INFORMATION BULLETIN NO. 103

TO: SPECIFIC OWNERS OF CDR ROOF DRILLS

**SUBJECT: GUARD BETWEEN THE MACHINE FRAME AND THE
DUST BOX**

DUST BOX GUARD
PART NO. 401703

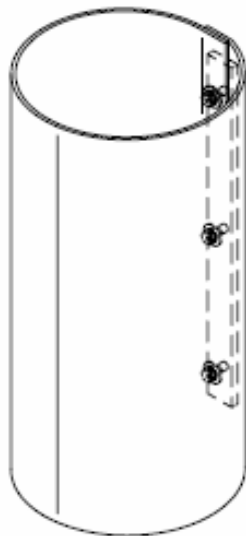
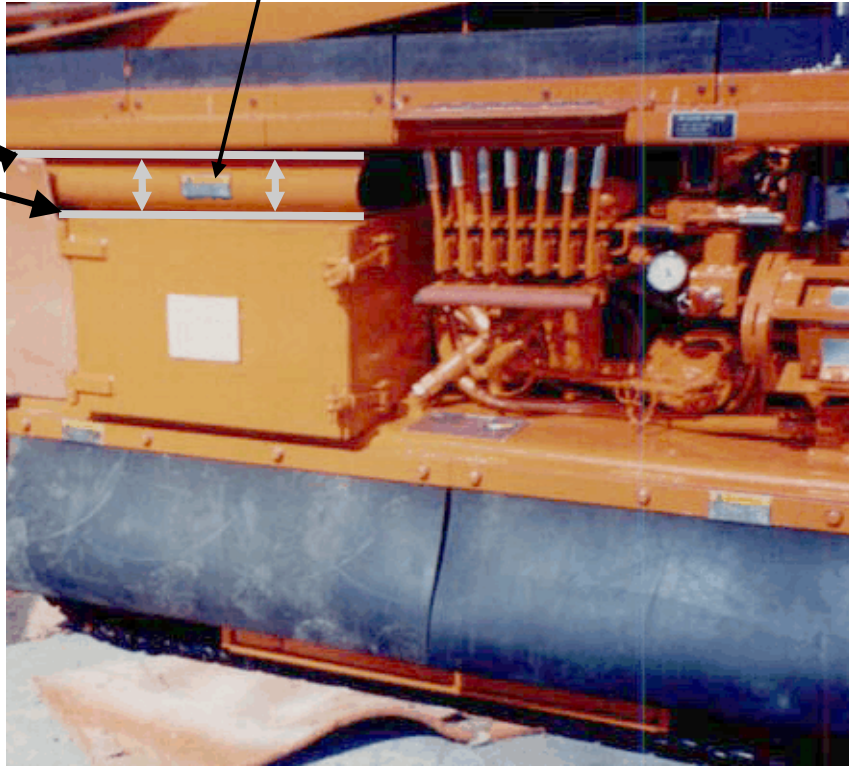
A pinch point is created when the machine is articulated (see Attachment 1). The area between the dust box and the machine frame is reduced when the machine chassis frame is moved up or down by a control (articulation) lever in the tram deck or positioning control station. Any body part that is positioned in this area during the articulating mode could be crushed resulting in amputation and/or serious and permanent injury.

In a continued effort to prevent potential injuries while using Fletcher equipment, Fletcher will provide a free guard (Part number: 401703, see Attachment 1) for installation on your machine. The guard must be permanently placed in the appropriate location between the cover plates and the dust box (generally located on the right side of the machine).

Your Fletcher field service representative can permanently attach the guard by welding it on or securing it to the bottom of the cover plates (see Attachment 1). **Your Fletcher representative will be in contact with you to schedule a convenient time to have the guard installed.**
